Access Compliance Report

Public Rights-of-Way

(Pedestrian Signals)

Intersection ID: N/A	Main Street:	Cross Street: N/A	Location: N/A
ADA ID: 59C8ACBB2683	Signal Type: One Push Button-Non APS	Overall Compliance: No	Severity Score: BTN 1: N/A BTN 2: N/A No BTN: N/A
Codes/Mitigation Info/Possible Solution		Field Measurements/Component Compliance

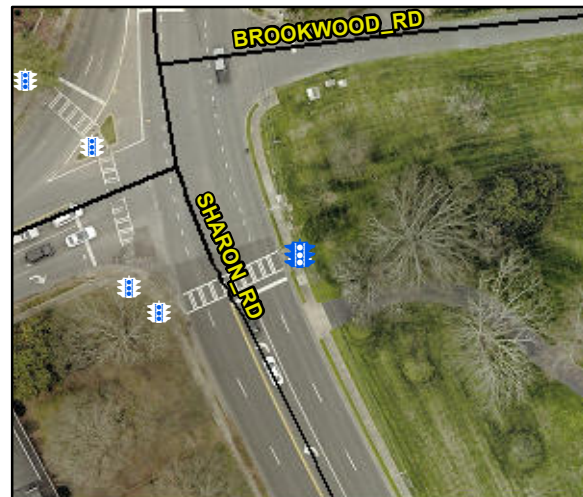
PROW/ADA: TMUTCD 4e.08, R404.2, R404.7.3

Possible Solutions: Replace Signal Push Button With APS Button on New Post. Remove & Relocate Sign.
